Manel Fashion Ltd.

79/1, Bason, Viti Para, Gazipur.
(23.962769N, 90.357361E)
26th January 2021

Buildings Information

Non engineered connections

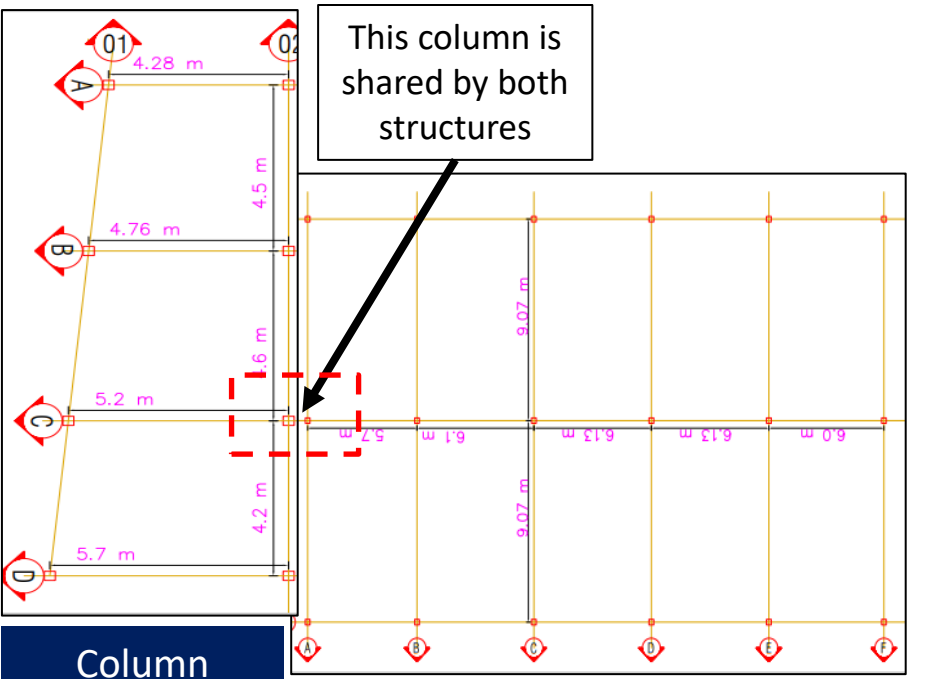
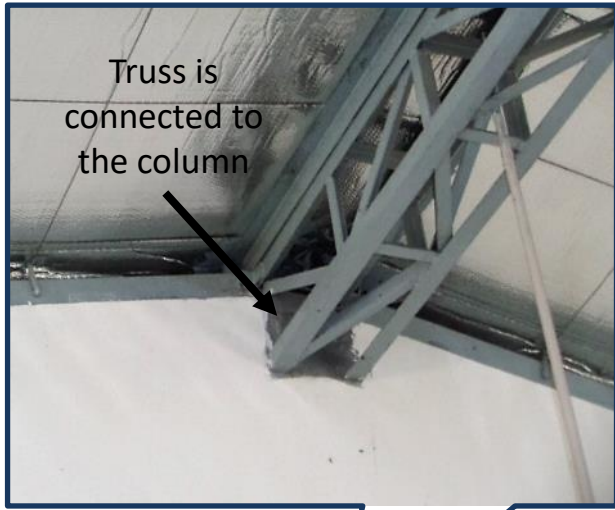
Lack of lateral stability system

Apparently improper connection was observed in roof shed. Also, the stability system observed was found to be inadequate. Building engineer is required to check the lateral stability of the shed and prepare design report in compliance with section 1.9.1 (part-6, BNBC).
